**U. S. Steel
Mining Co., Inc.**

Re: Abatement Plans
NOV N84-2-13-1

WELLINGTON COAL CLEANING PLANT
PROPOSED SLURRY DISCHARGE
CONTAINMENT BASIN
LOCATION MAP

A9-1449

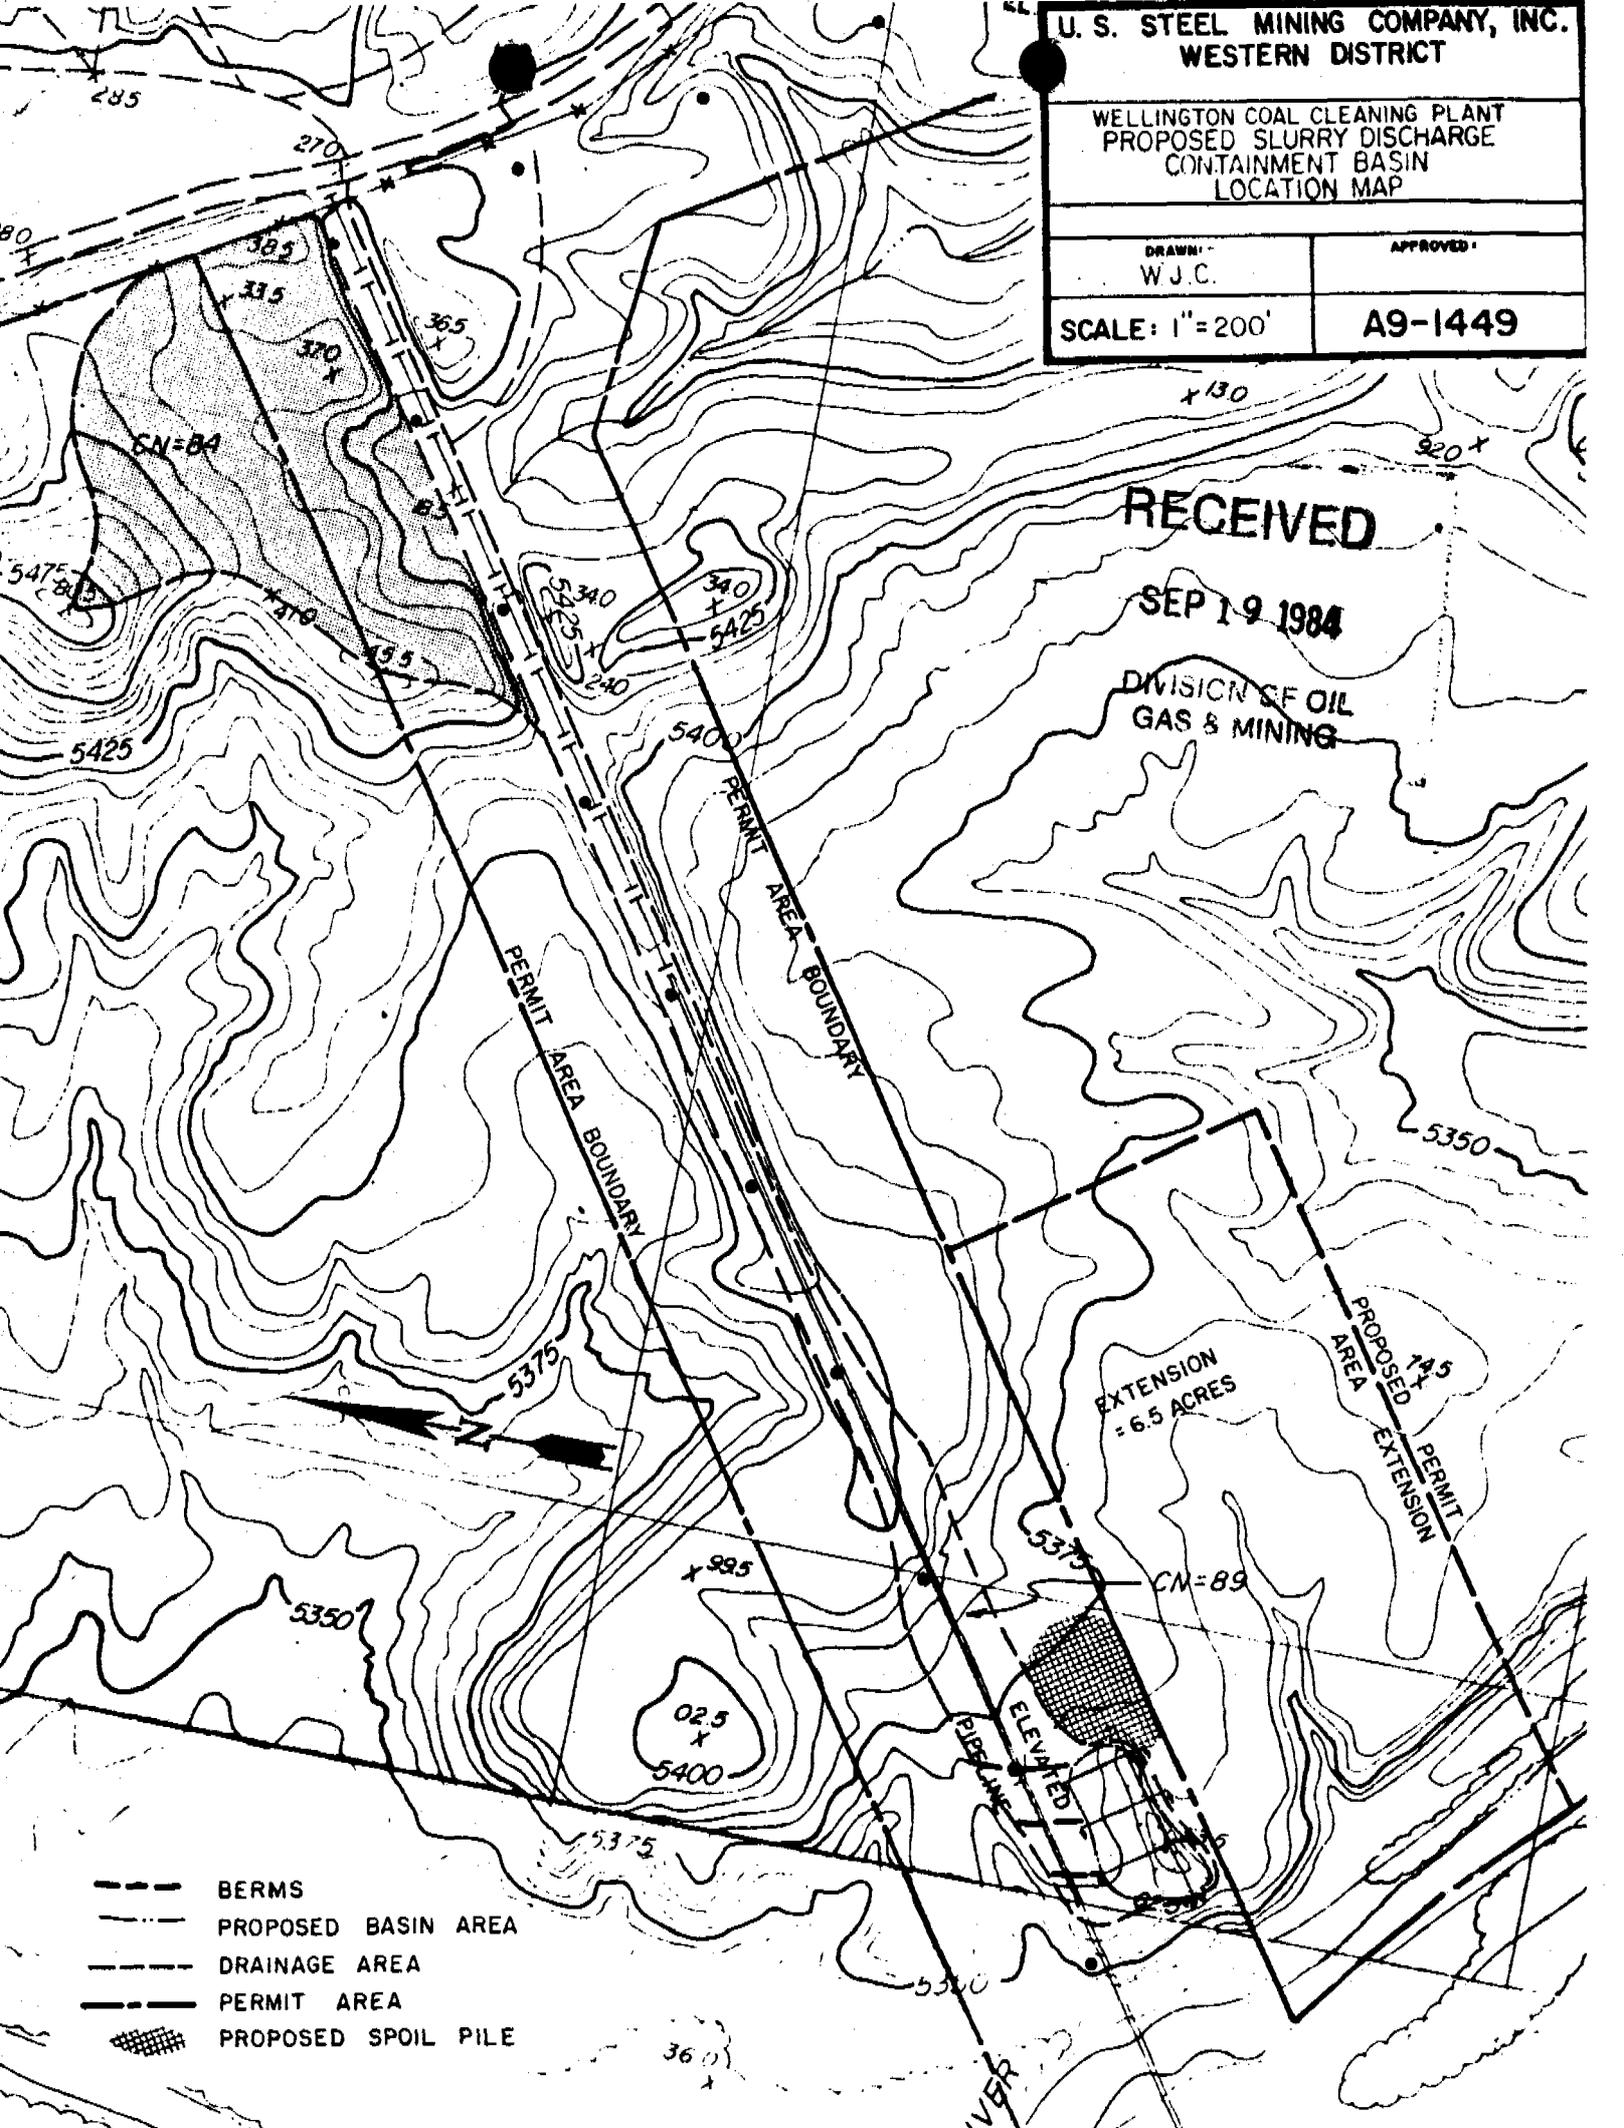
- (1) Drawing E9-3450 which proposes modifications to the existing structure to adequately meet the requirements of 817.46(e)-(u).
- (2) Map A9-1449 which shows the hydrologic curve numbers and a proposed permit area extension.
- (3) Design storm runoff calculation sheets.

The present containment basin is located very close to the permit area boundary. U. S. Steel Mining Co., Inc. proposes to extend the permit area as shown on map A9-1449. This extension will provide additional room to properly install the proposed structure. This change will also allow additional area should future modifications prove necessary.

The proposed modifications will be conducted in an area which was previously disturbed as was noted in the original submittal. Therefore, it will not be necessary to salvage and store topsoil. Spoil from the pond excavation will be stored as shown on map A9-1449.
